FILMED FIRST ISSUE BY APS PER ESR 92-172 APP'D: CAT 09-3-92 FILMED:(APS) 10-12-93

APM-547

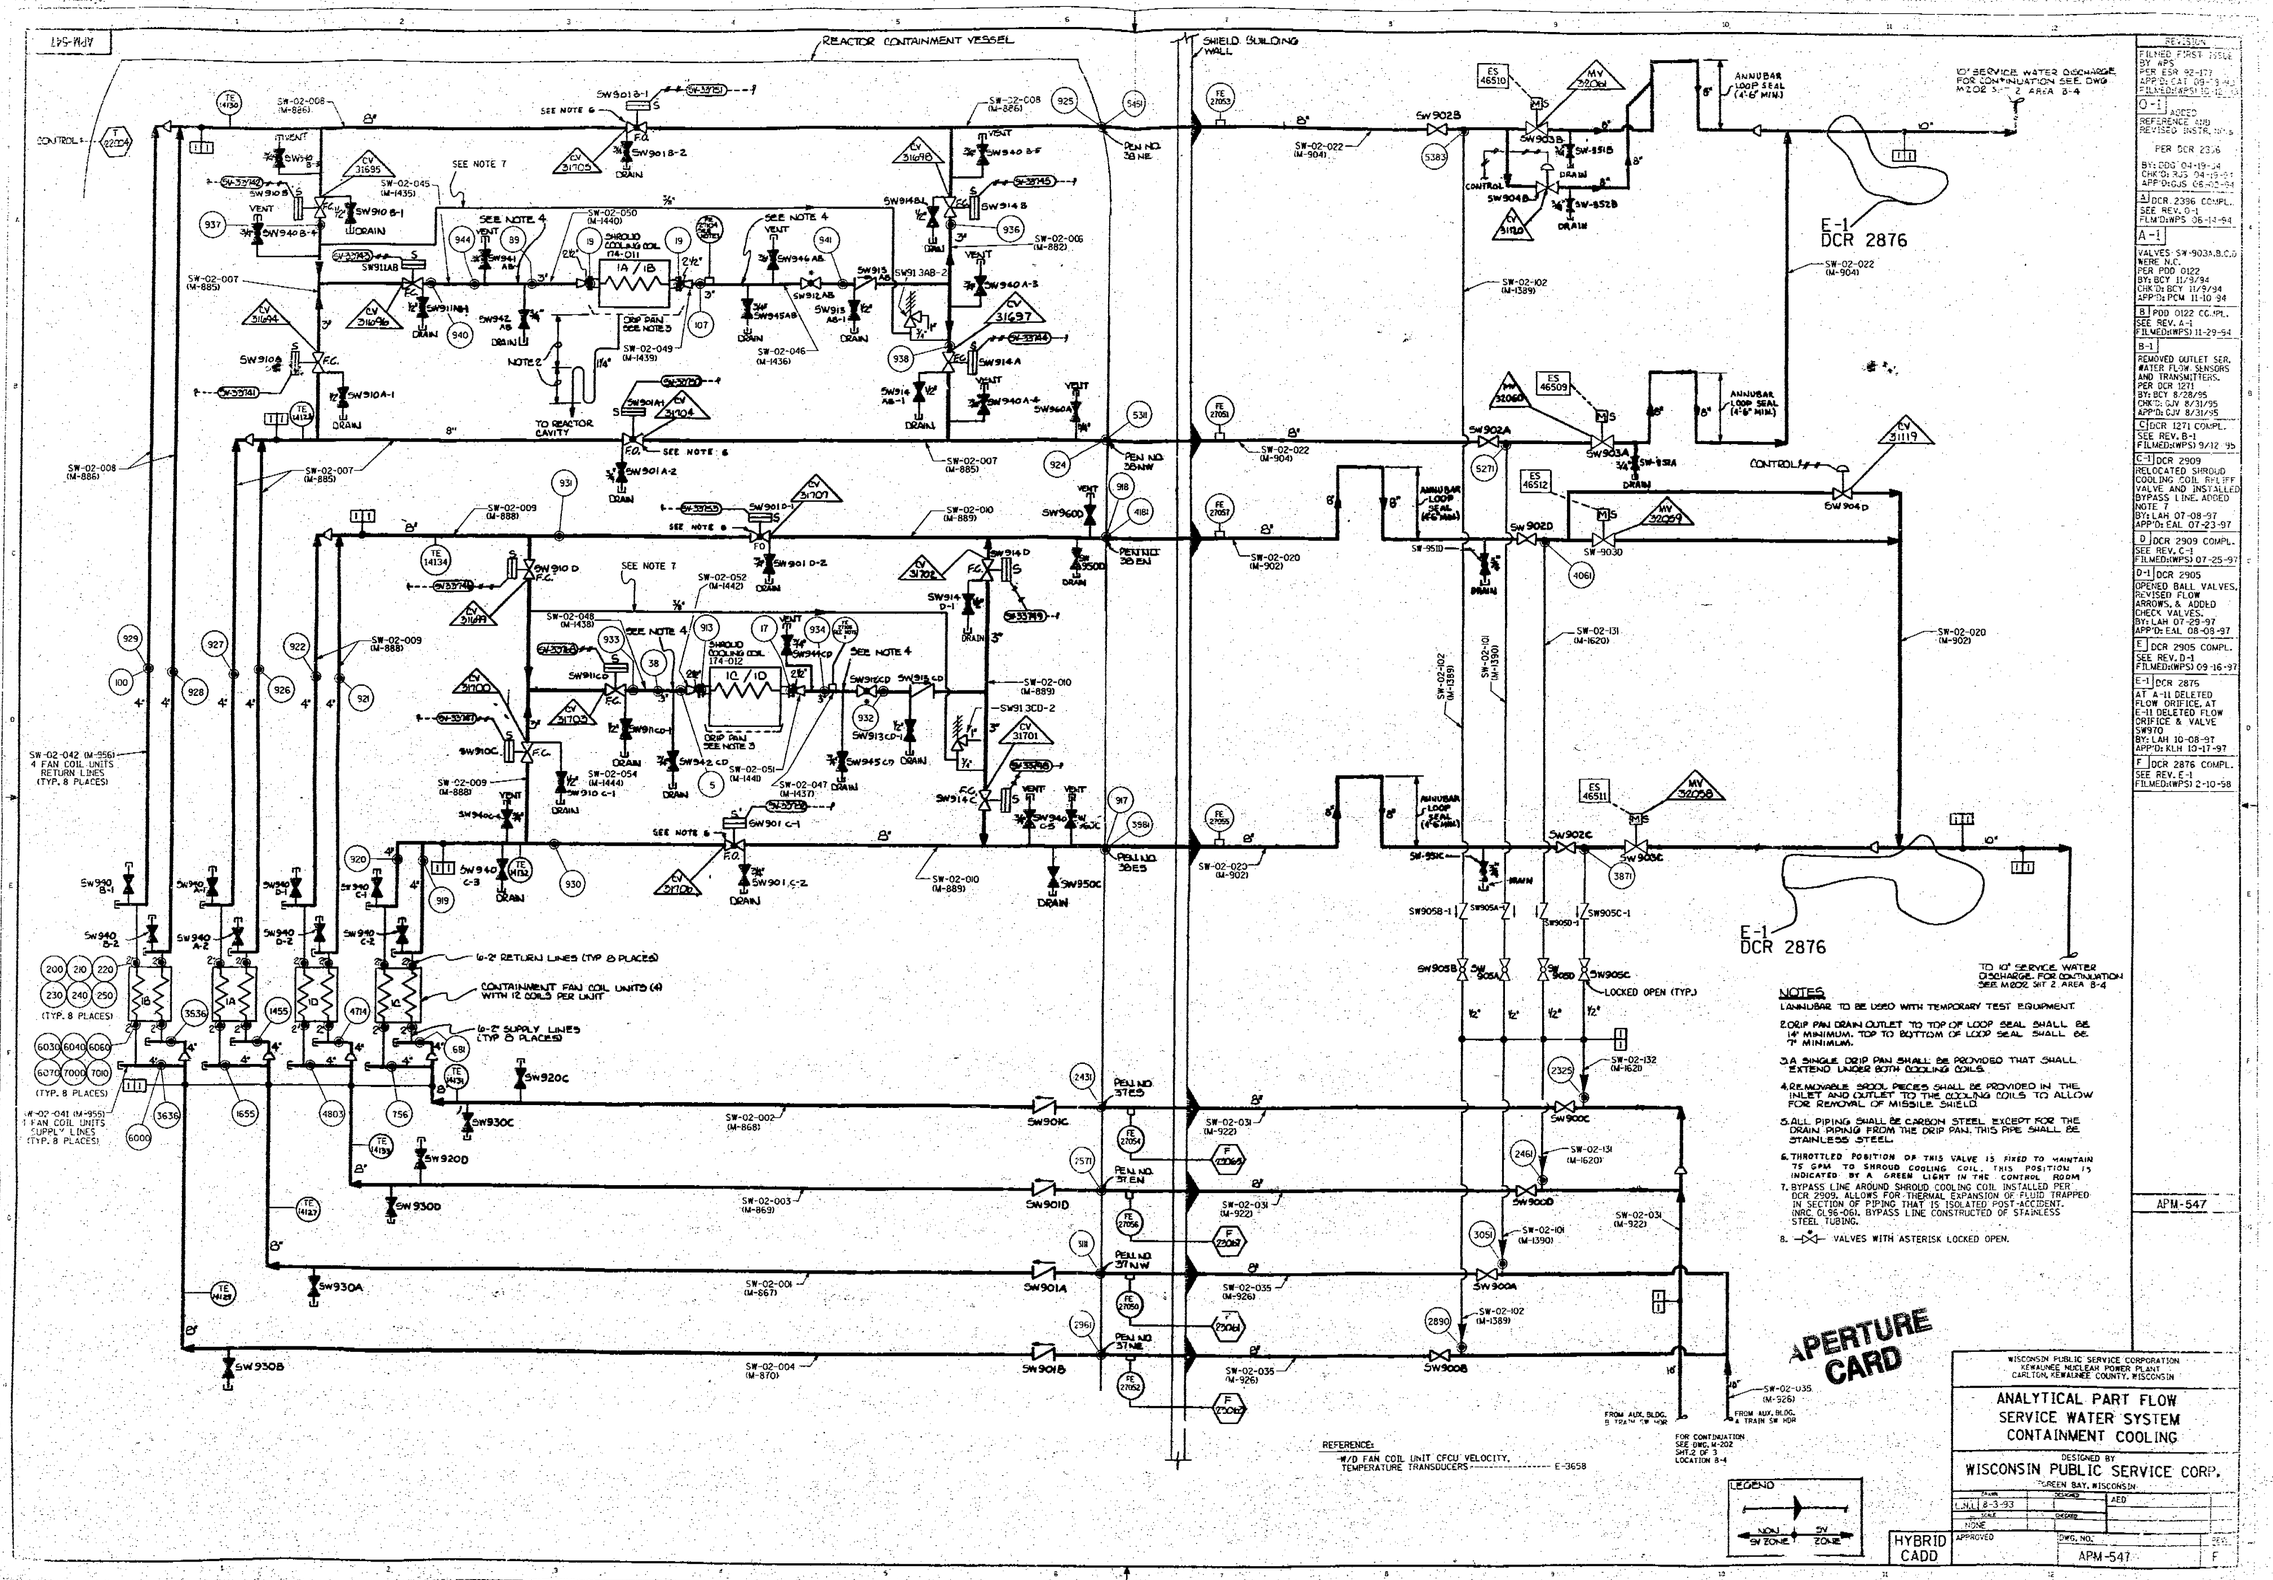
0-1 ADDED REFERENCE AND REVISED INSTR. NOTE PER DCR 2316 BY: DDG 04-19-94 CHK'D: RJS 04-19-94 APP'D: GJS 06-13-94

A-1 VALVES SW-903A,B,C,D WERE N.C. PER PDD 0122 BY: BCY 11/9/94 CHK'D: BCY 11/9/94 APP'D: PCM 11-10-94

B-1 REMOVED OUTLET SER. WATER FLOW SENSORS AND TRANSMITTERS. PER DCR 1271 BY: BCY 8/28/95 CHK'D: GJV 8/31/95 APP'D: GJV 8/31/95

C-1 DCR 2909 RELOCATED SHROUD COOLING COIL RELIEF VALVE AND INSTALLED BYPASS LINE. ADDED NOTE 7 BY: LAH 07-08-97 APP'D: EAL 07-23-97

D-1 DCR 2905 OPENED BALL VALVES. REVISED FLOW ARROWS, & ADDED CHECK VALVES. BY: LAH 07-29-97 APP'D: EAL 08-08-97

E-1 DCR 2876 AT A-11 DELETED FLOW ORIFICE. AT E-11 DELETED FLOW ORIFICE & VALVE SW970 BY: LAH 10-08-97 APP'D: KLH 10-17-97

7. BYPASS LINE AROUND SHROUD COOLING COIL INSTALLED PER DCR 2909. ALLOWS FOR THERMAL EXPANSION OF FLUID TRAPPED IN SECTION OF PIPING THAT IS ISOLATED POST-ACCIDENT. (NRC 0L96-061). BYPASS LINE CONSTRUCTED OF STAINLESS STEEL TUBING.
